CRMC DECISION WORKSHEET

**STATE OF RHODE ISLAND
COASTAL RESOURCES MANAGEMENT COUNCIL
ENGINEERING REVIEW**

SUBJ: **CRMC File No.:** A2021-10-062

Project: Reconstruction of an existing boat ramp with replacement and expansion of the existing floating docks that are adjacent to the ramp.

DEMOLITION AND SEDIMENTATION & EROSION CONTROL PLAN
SCALE: 1" = 10'-0"

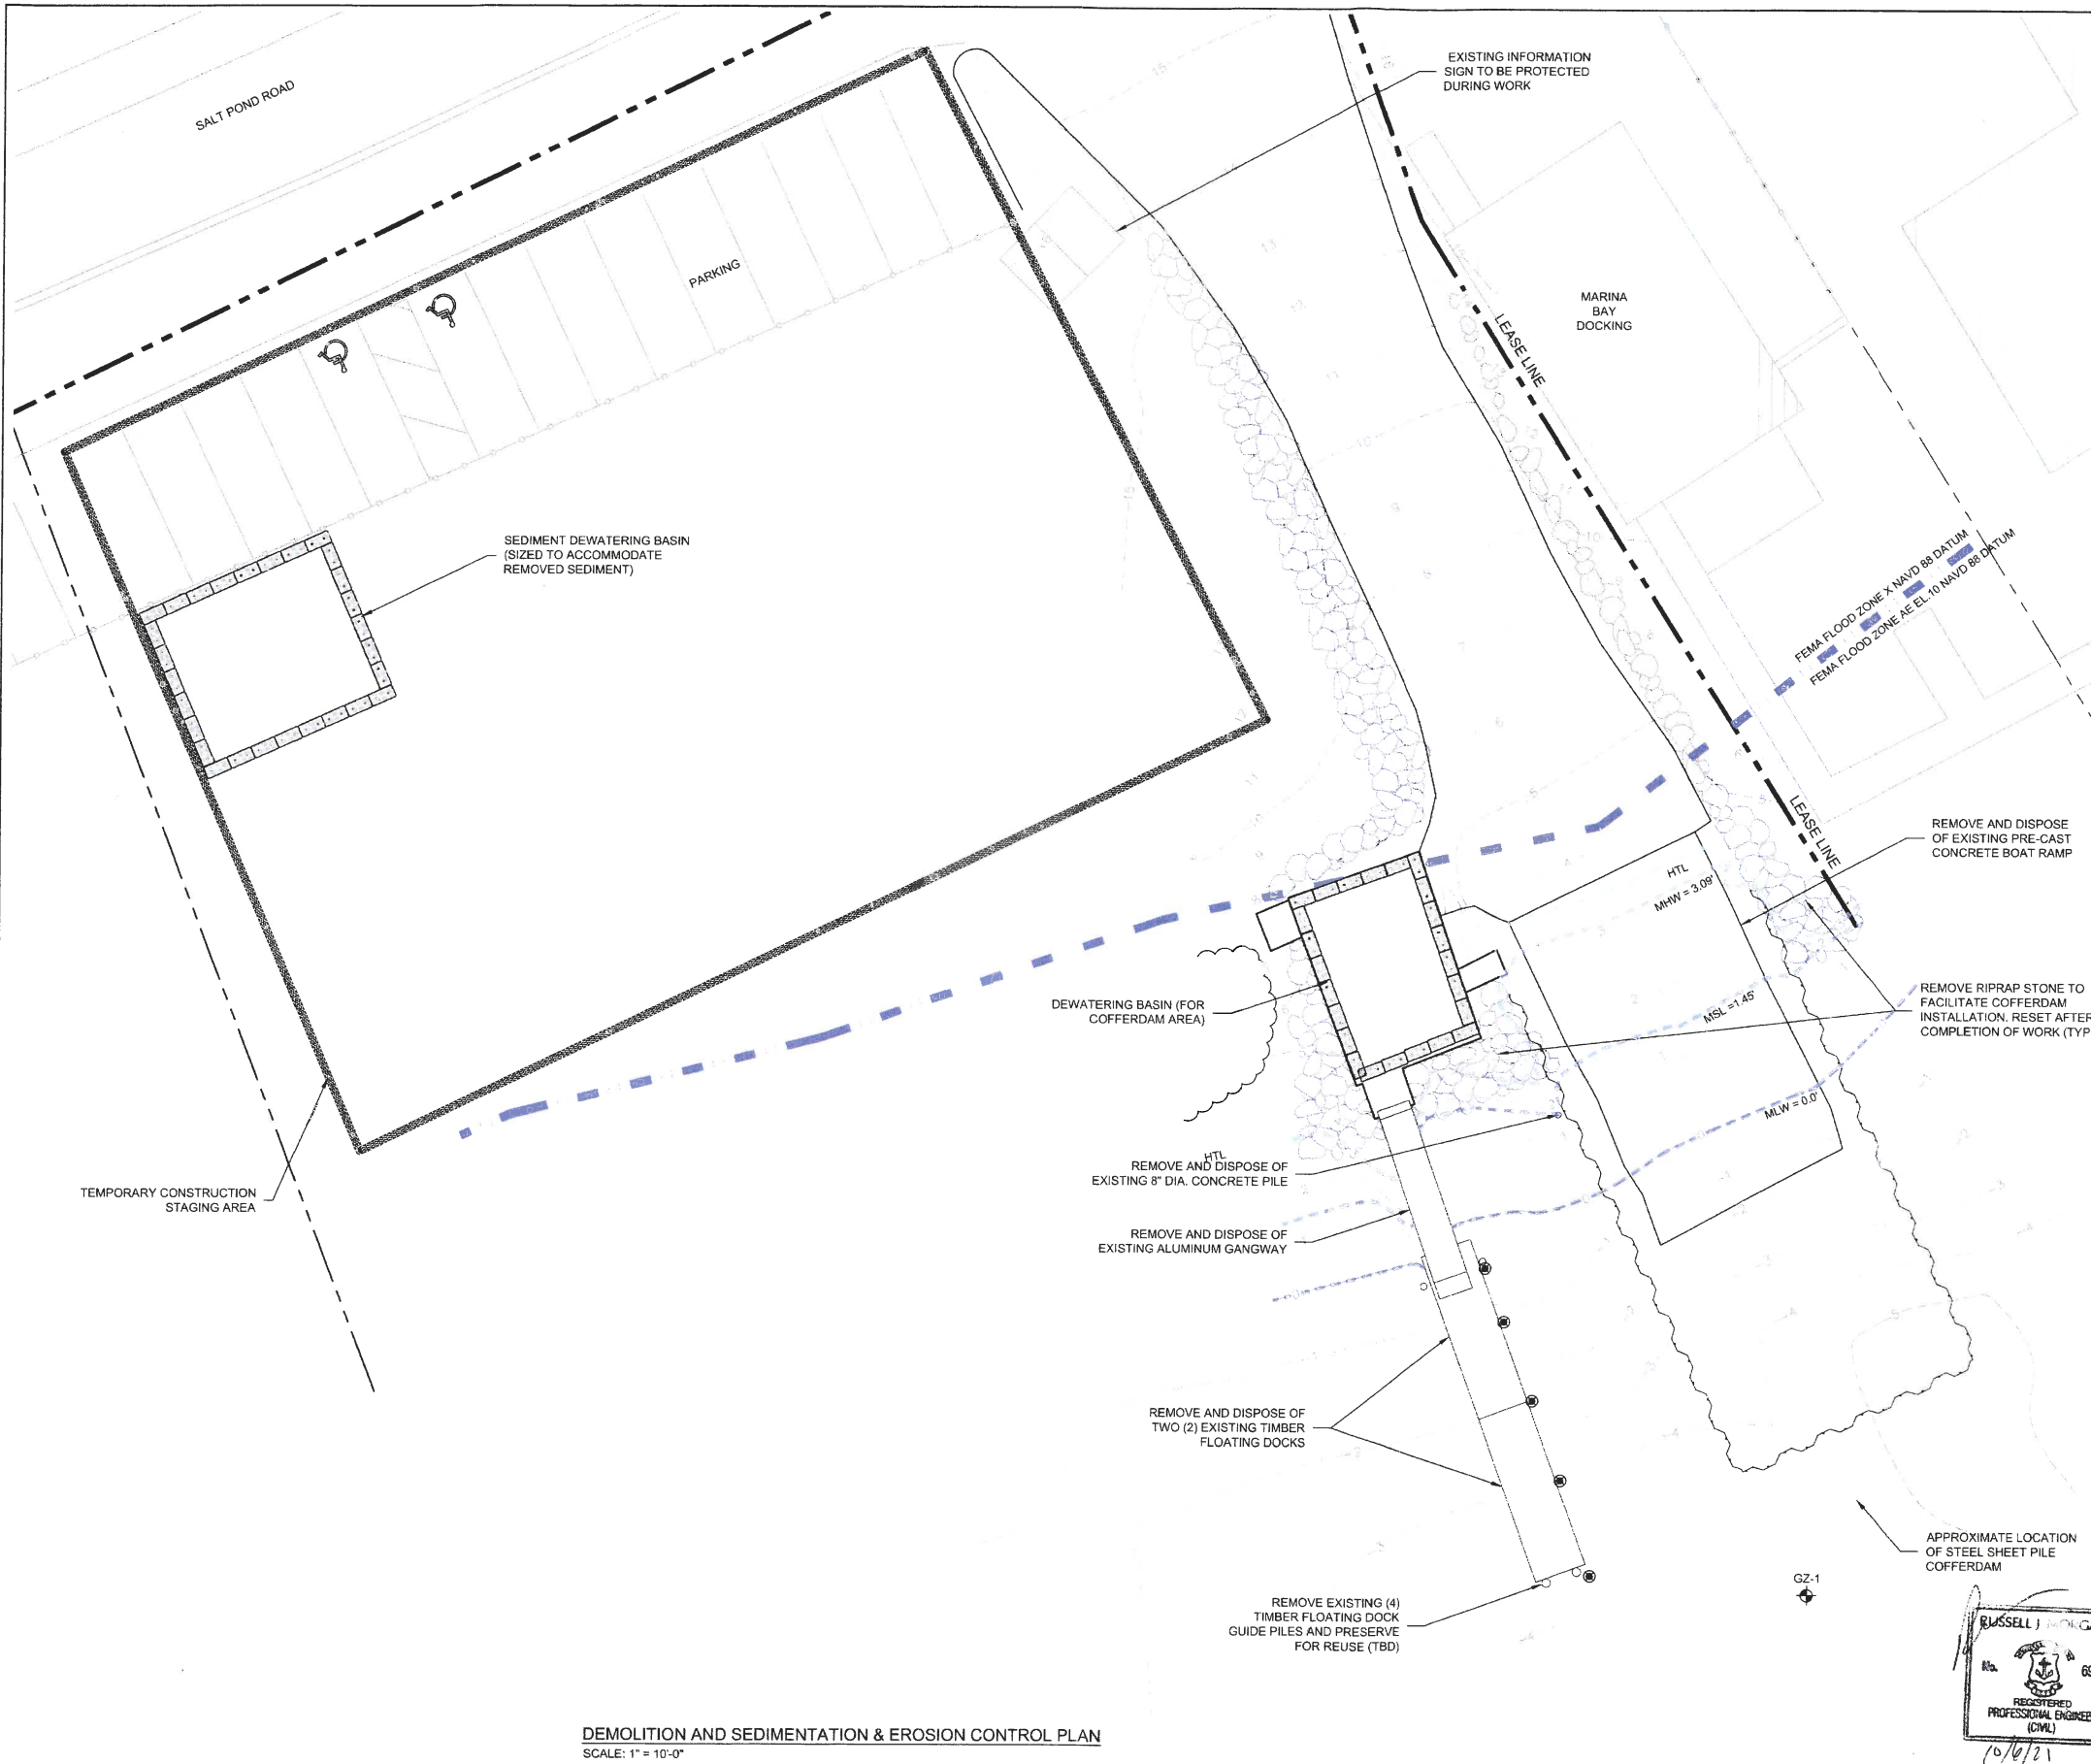
- 2) Prior to construction, proper erosion and sedimentation controls/procedures, as identified in the above-referenced plans, are installed and maintained in functional condition for the duration of the construction project.

PROJ MGR: RKT	DESIGNED BY: RKT	REVIEWED BY: RJM	CHECKED BY: MJP
DATE: SEPTEMBER 2021	PROJECT NO: 34932.00	DRAWN BY: TRM	SCALE: AS NOTED
			REVISION NO: 0
FIGURE 6

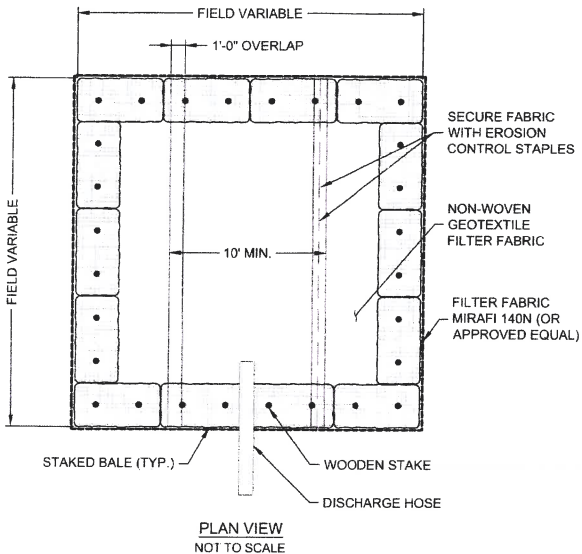
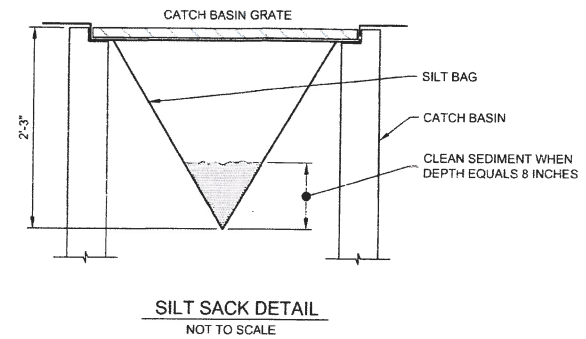
- 7) No dredging beyond the limits of the steel sheet pile cofferdam, as depicted on sheet 6 of the above-mentioned plans, is authorized under this approval.

- 8) The temporary steel sheet pile cofferdam must be completely removed upon construction completion; the cofferdam shall not be cut and left in-place.
